Service Letter: No. 343

Subject: Modification to Bell 407 Air Conditioner Belt Tensioning Collar in conjunction with Bell Helicopter Technical Bulletin No. 407-02-35.

Applicability: Bell Helicopter Model 407 equipped with Air Comm Corporation Air Conditioner System.

Reference: F.A.A. / S.T.C. SR00222DE
Drawing # 407EC-300 Rev U

Figure 1-1, Modification of S-3010EC-5 Belt Tensoning Collar. View Looking Forward

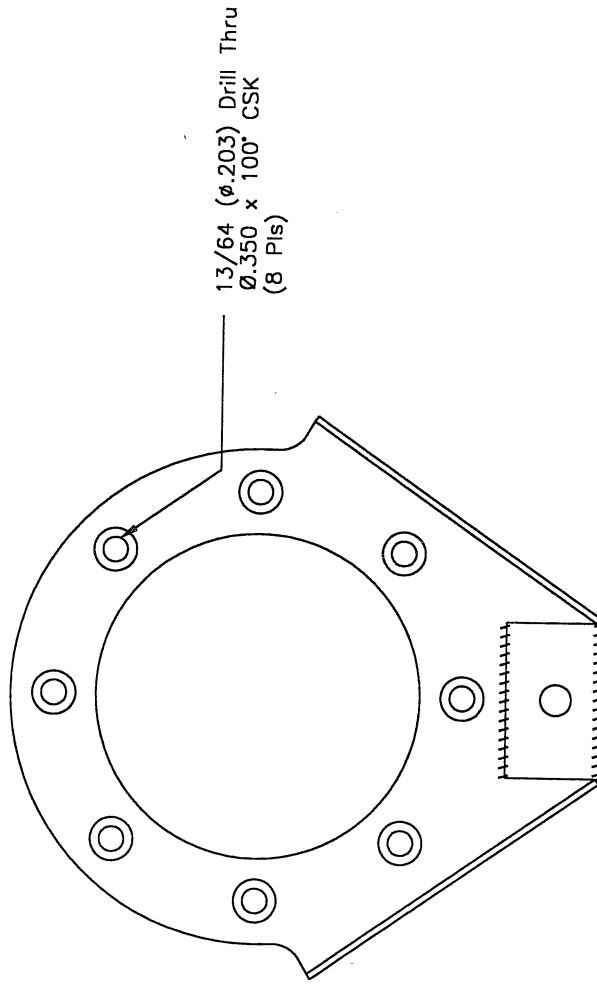
It is therefore necessary to modify the existing belt tensioning collar to accommodate countersunk screws, thus maintaining the necessary clearance between the air conditioner drive pulley and the belt tensioning collar assembly.

Modification: (See Figure 1-1.)

1. Insure all surfaces of the S-3010EC-5 Belt Tensioning Collar are clean and free of Pro-Seal.
2. Using an $\text{Ø} .350 \times 100^\circ$ Counter Sink Tool, or Equivalent. Countersink all eight (8) existing mounting holes in the forward facing side of the S-3010EC-5 Belt Tensioning Collar.

Figure 1-2, Installation of Modified S-3010EC-5 Belt Tensioning Collar. View looking Aft.

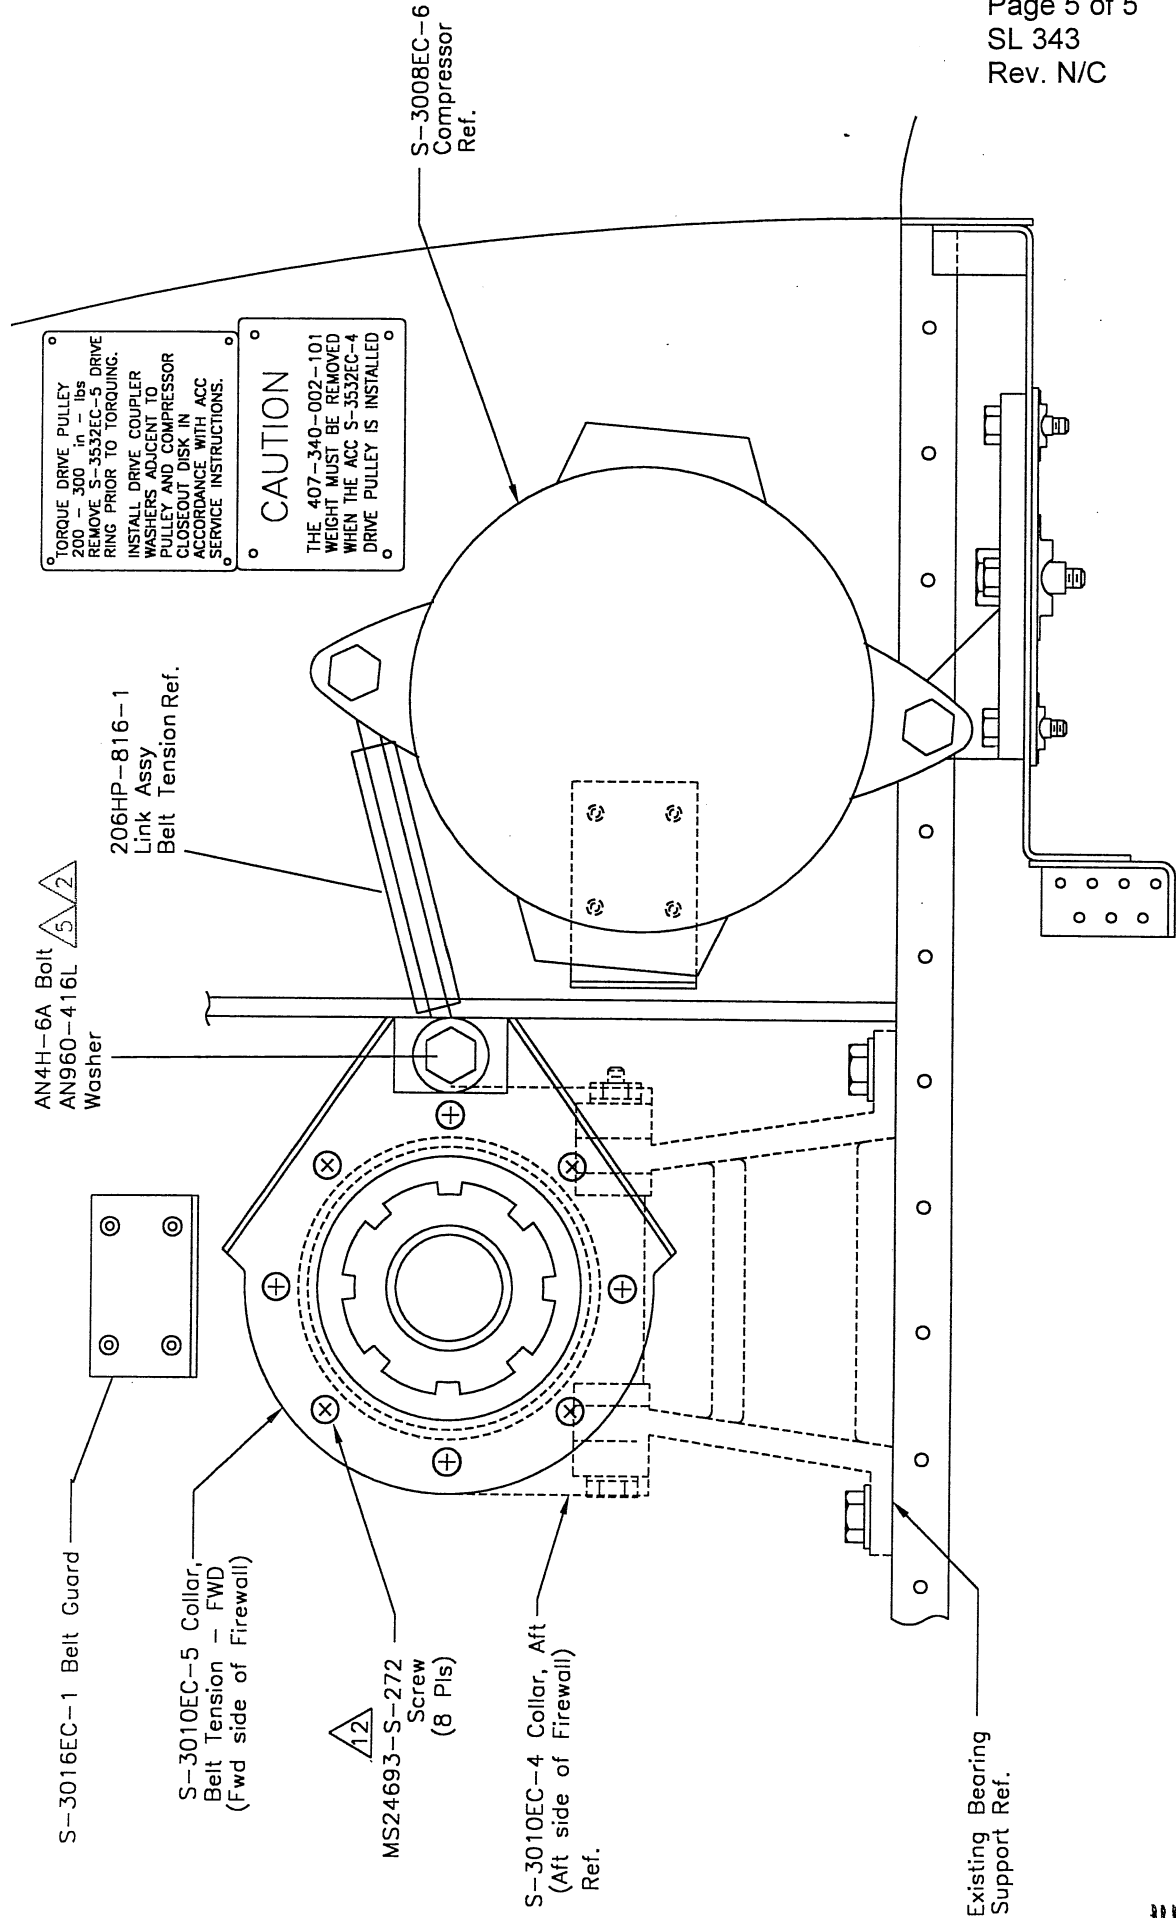
Installation: (See Figure 1-2)

1. Reinstall the modified S-3010EC-5 Belt Tensioning Collar using eight (8) MS24693-S-272 Screws (See Note 12)
2. Reinstall the AN4H-6A Bolt, AN960-416L Washer(s) (See Note 5) & 206HP-816-1 Belt Tension Link, Torque AN4H-6A Bolt 50 to 70 inch lbs.
3. On completion of Bell Helicopter Technical Bulletin 407-02-35, reinstall Compressor Drive Belt between the Compressor, and the Compressor Drive Pulley. Tension the belt using the 206HP-816-1 Belt Tensioning Link to a static belt tension of 52 lbs.
4. Safety AN4H-6A Bolt and 206HP-816 Belt Tension Link (See Note 2).
